SUNDRY NOTICES AND REPORTS ON WELLS

8. Well Name and No. IGOR 33 FED COM/204H

EOG respectfully requests an amendment to our approved APD for this well to reflect the following changes:

Inga 33 Fed Com 586H (FKA Igor 33 Fed Com 204H) API #: 30-025-49447

WELL LOCATION AND ACREAGE DEDICATION PLAT

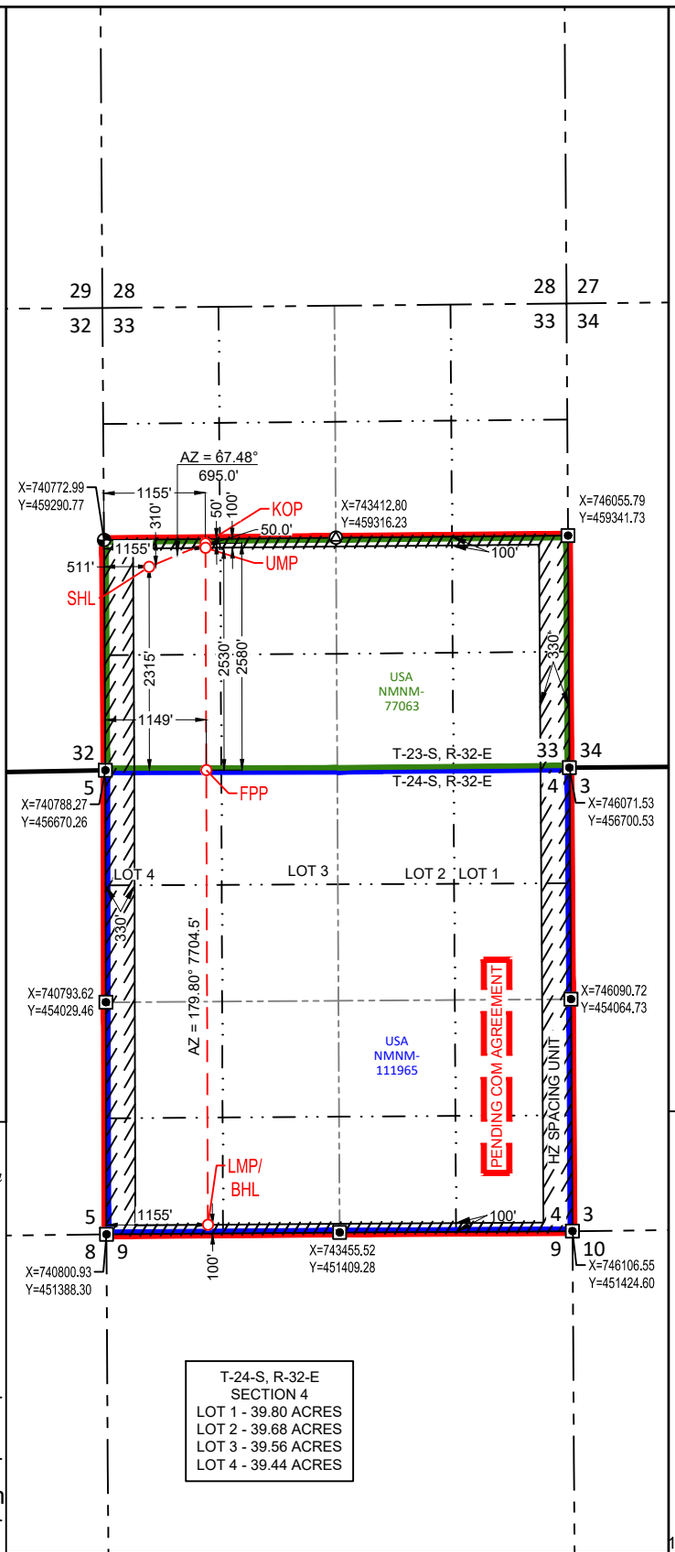
Change name from Igor 33 Fed Com 204H to Inga 33 Fed Com 586H.

Change SHL from T-23-S, R-32-E, Sec 33, 462' FSL, 2529' FEL, Lea Co., NM,
to T-23-S, R-32-E, Sec 33, 2315' FSL, 511' FWL, Lea Co., N.M...

.Change BHL from T-23-S, R-32-E, Sec 28, 100' FNL, 1830' FEL, Lea Co., NM,
to T-24-S, R-32-E, Sec 4, 100' FSL, 1155' FWL, Lea Co., N.M.

UL or lot no.	Section	Township	Range	Lot Idn	Feet from the	North/South line	Feet from the	East/West line	County
L	33	23-S	32-E	-	2315'	SOUTH	511'	WEST	LEA

UL or lot no.	Section	Township	Range	Lot Idn	Feet from the	North/South line	Feet from the	East/West line	County
M	4	24-S	32-E	-	100'	SOUTH	1155'	WEST	LEA

Dedicated Acres	Joint or Infill	Consolidated Code	Order No.
958.48			PENDING COM AGREEMENT

Revised Wellbore A:

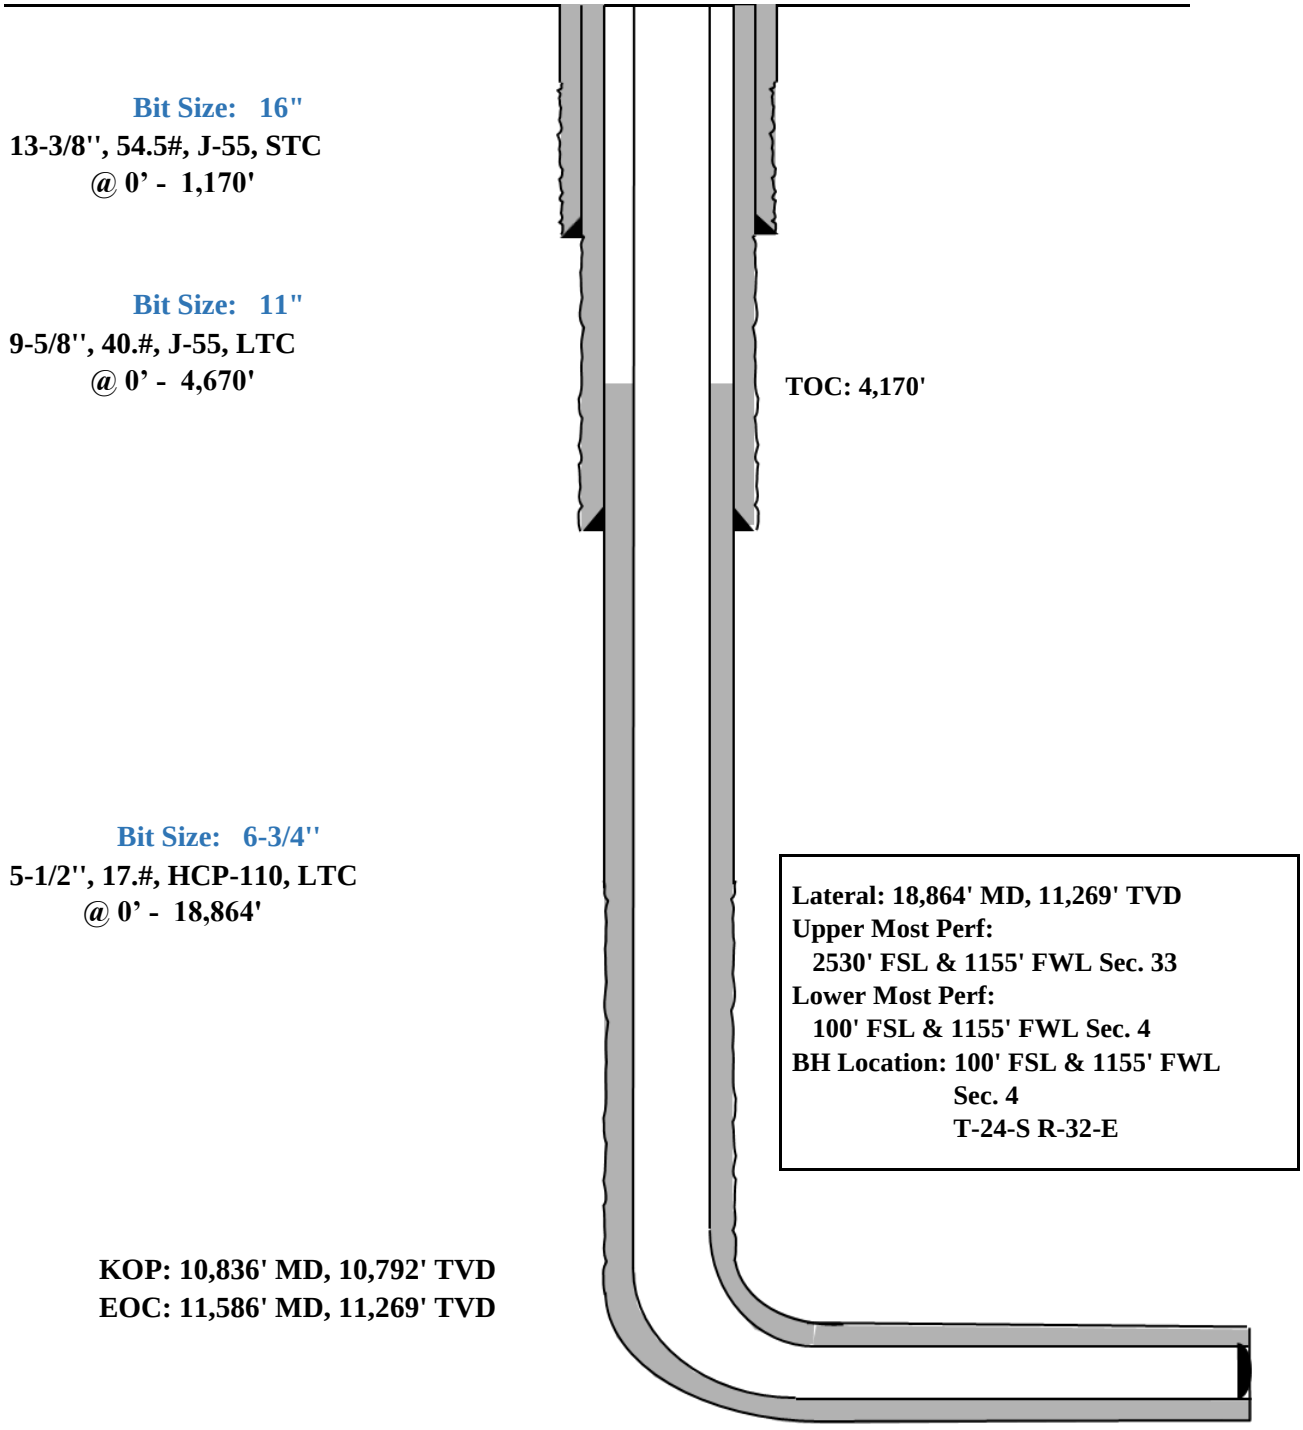
Update casing and cement program to current design.

Bit Size: 16"
13-3/8'', 54.5#, J-55, STC
@ 0' - 1,170'

Bit Size: 11"
9-5/8'', 40.#, J-55, LTC
@ 0' - 4,670'

Bit Size: 6-3/4''
5-1/2'', 17.#, HCP-110, LTC
@ 0' - 18,864'

Lateral: 18,864' MD, 11,269' TVD
Upper Most Perf:
2530' FSL & 1155' FWL Sec. 33
Lower Most Perf:
100' FSL & 1155' FWL Sec. 4
BH Location: 100' FSL & 1155' FWL
Sec. 4
T-24-S R-32-E

KOP: 10,836' MD, 10,792' TVD
EOC: 11,586' MD, 11,269' TVD
